CHSS WITH MULTIPLE CONNECTED CHAMBERS AND REMOTE TPRDS.

BMW CONCEPT.

EG-823, EA-610

Proposal for 02 series of amendments to UN Regulation No. 134 (Hydrogen and Fuel Cells Vehicles)

CONTAINER DEFINITION ACC. R134 PHASE 2. COMMON UNDERSTANDING.

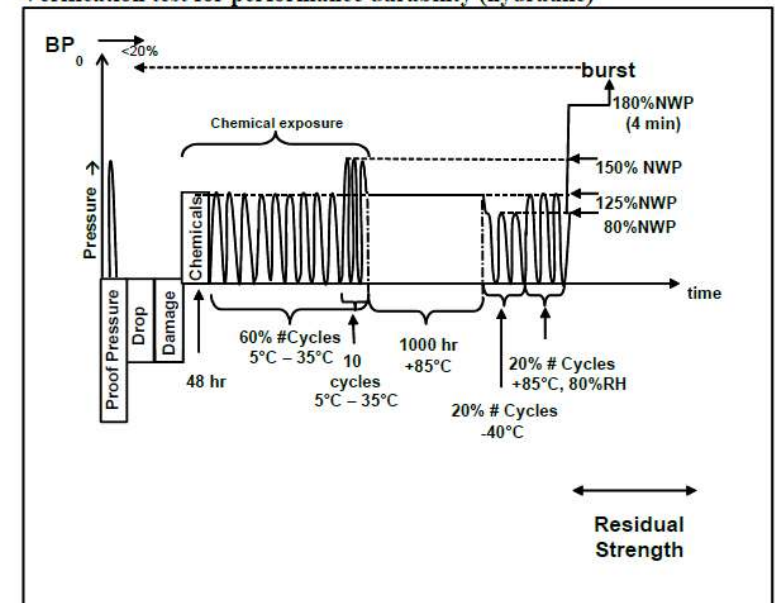
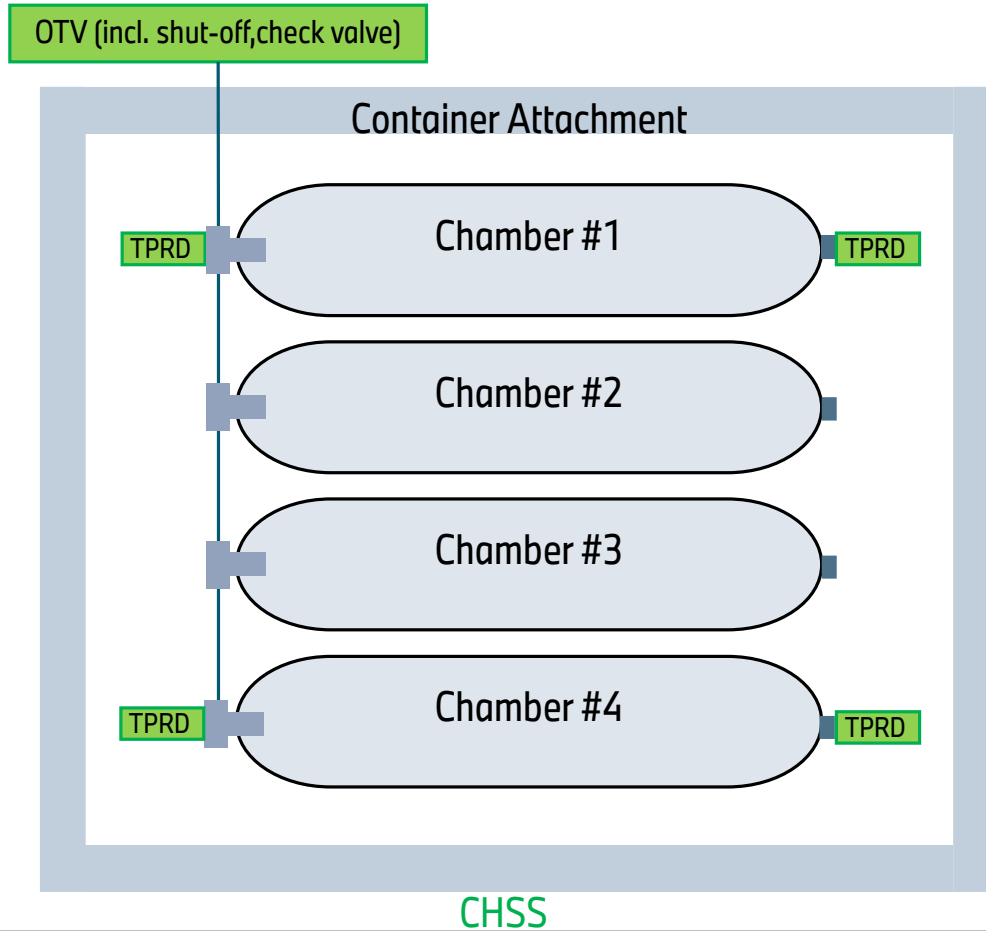
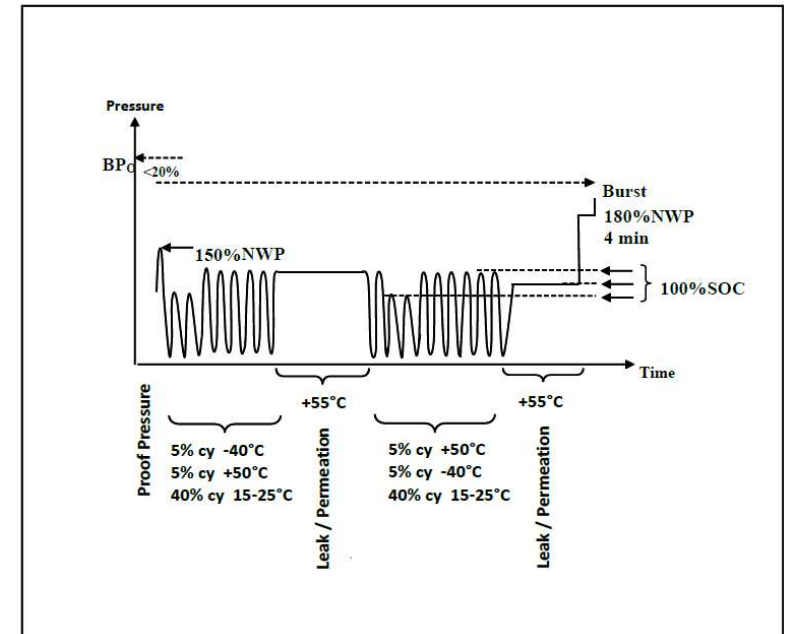
CHSS DEFINITION ACC. R134 PHASE 2. COMMON UNDERSTANDING.

CONTAINER DEFINITION ACC. R134 PHASE 2. BMW UNDERSTANDING.

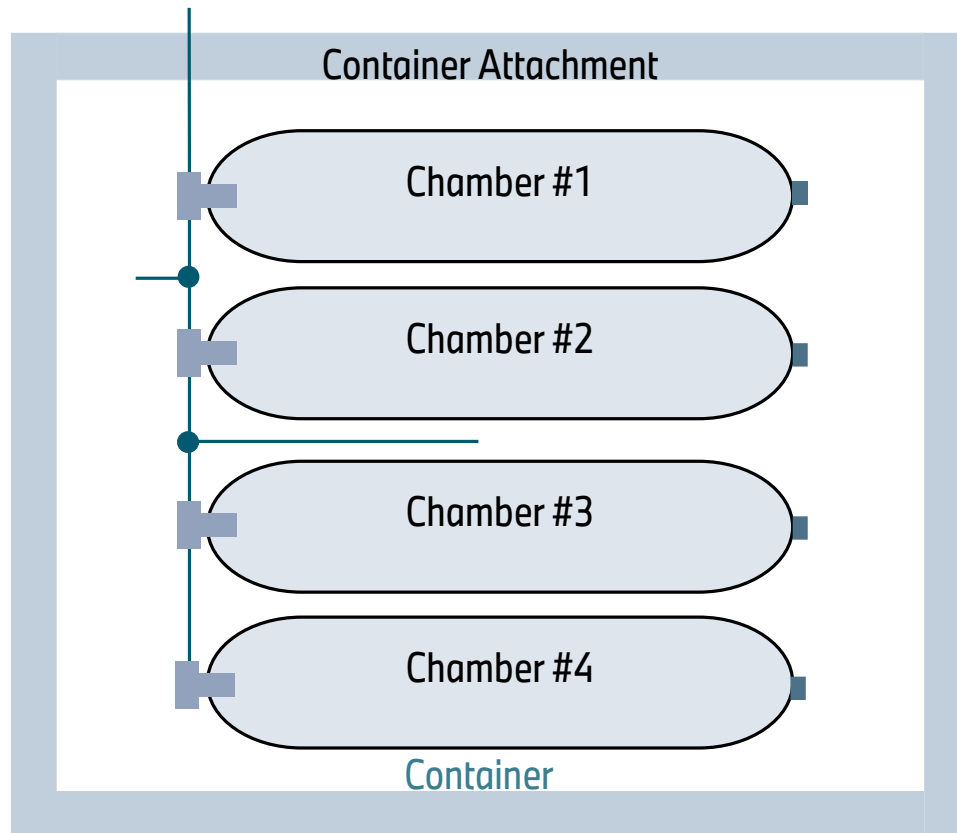
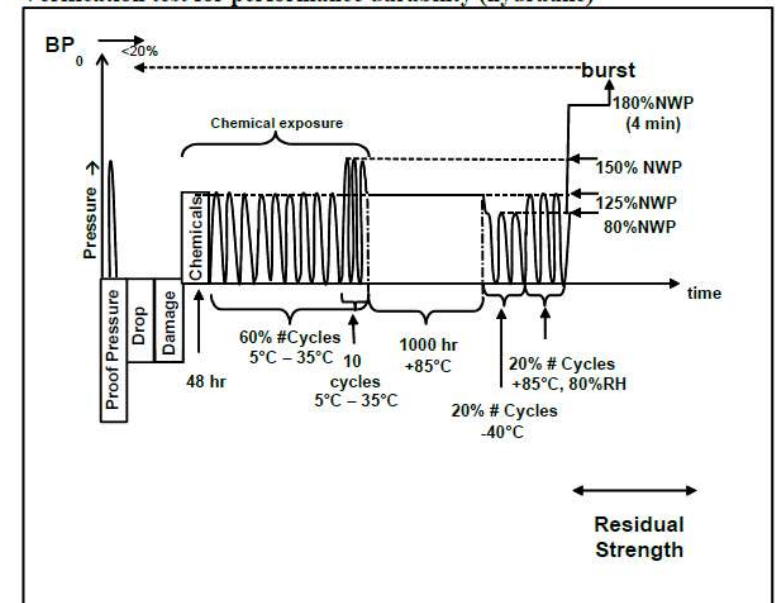
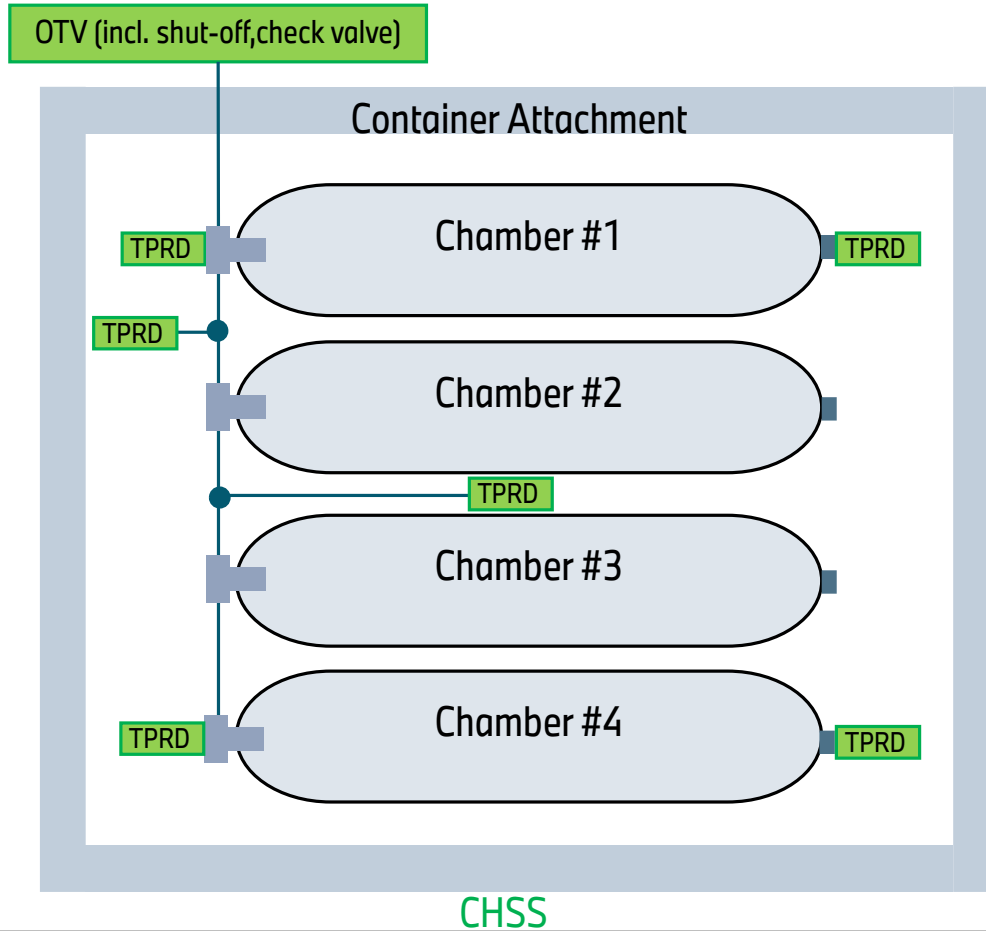
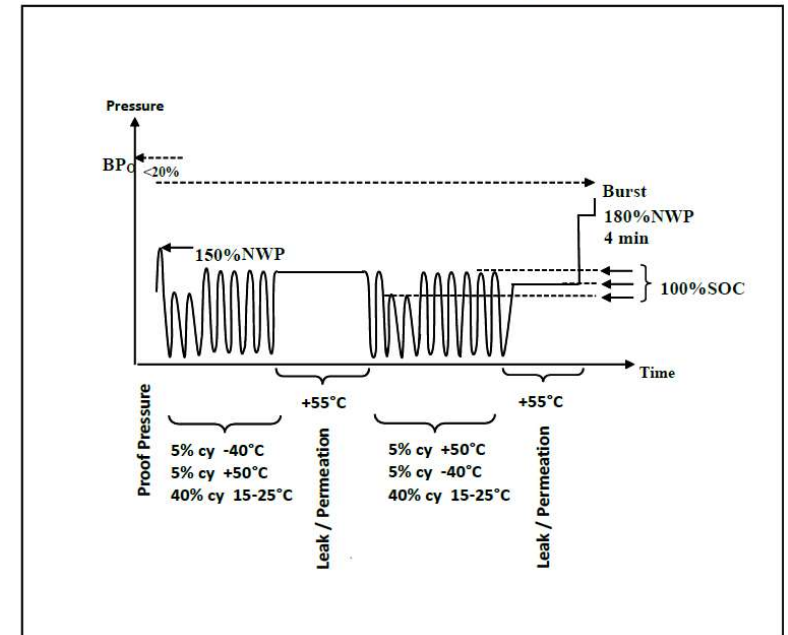
CHSS DEFINITION ACC. R134 PHASE 2. BMW UNDERSTANDING.

REMOTE TPRD. BMW UNDERSTANDING.

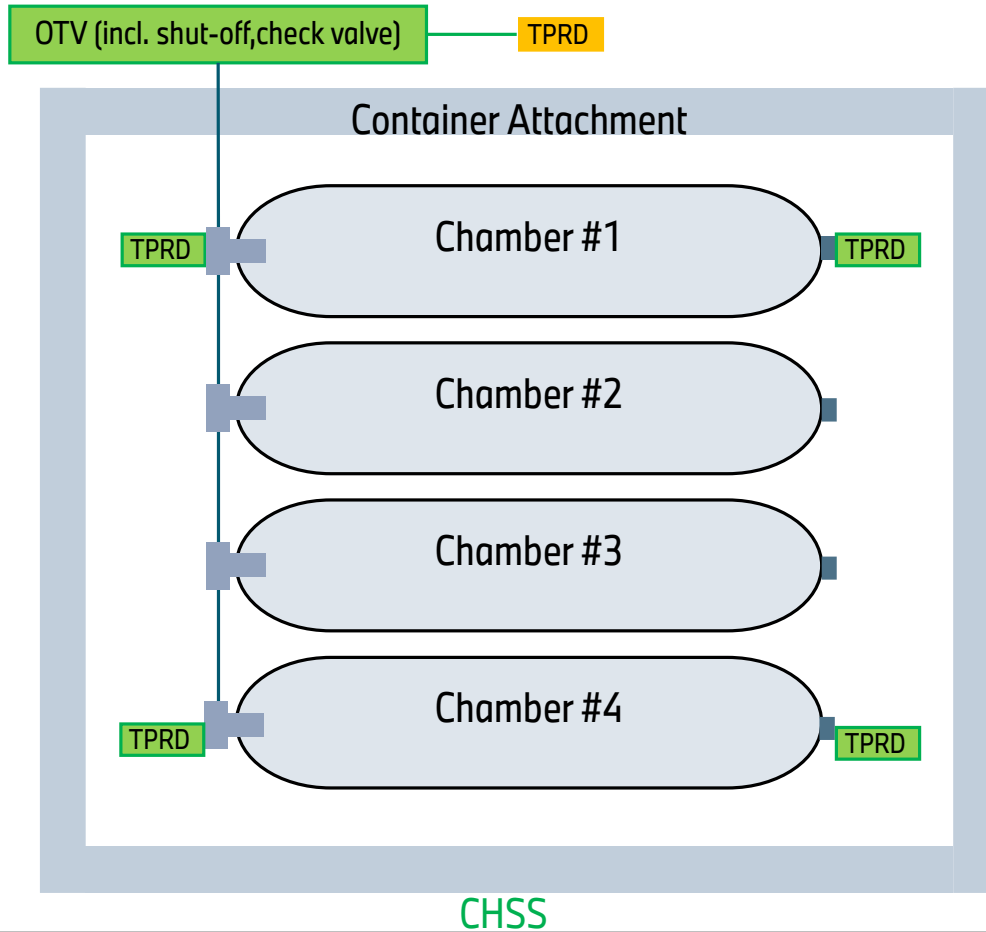
Symbol	Component
	Chamber
	Container Attachment
	T-Piece
	Primary closure devices
	Additional Remote TPRD

Classic TPRD as in GTR 13 Phase 1
